TT229 – January 23, 2006

2006 FLHTCUSE “CVO” Heated Seat

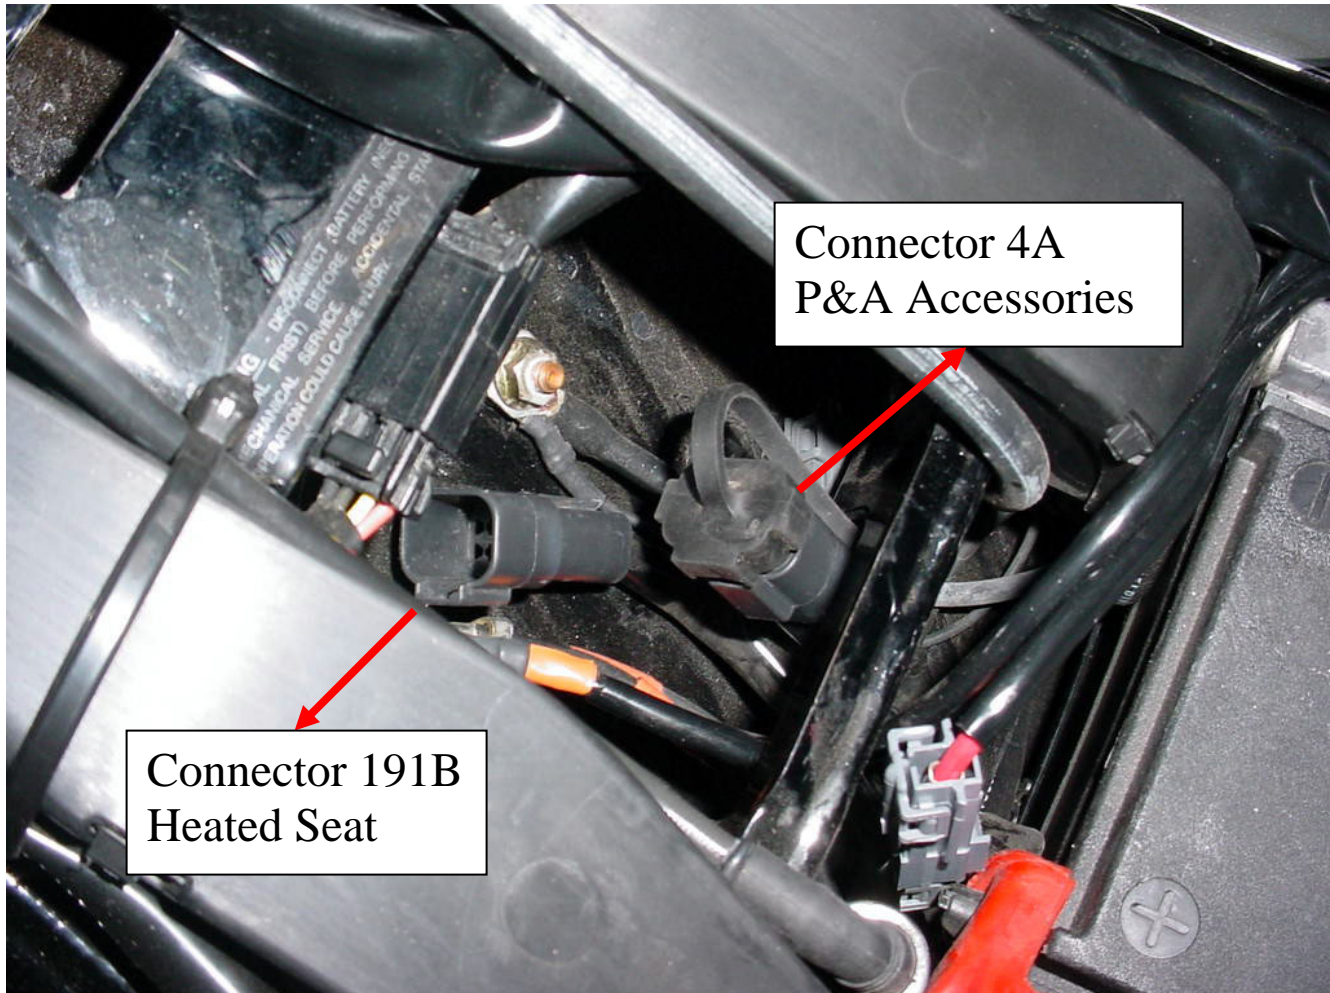
The seat on the 2006 FLHTCUSE is plugged into connector #191B; this connector is located near the accessory connector #4A which has a rubber plug in the connector. Make sure the seat is plugged into the correct connector, if it is not you would need to turn on the accessory switch to operate the seat. The picture below shows the 2 connectors.
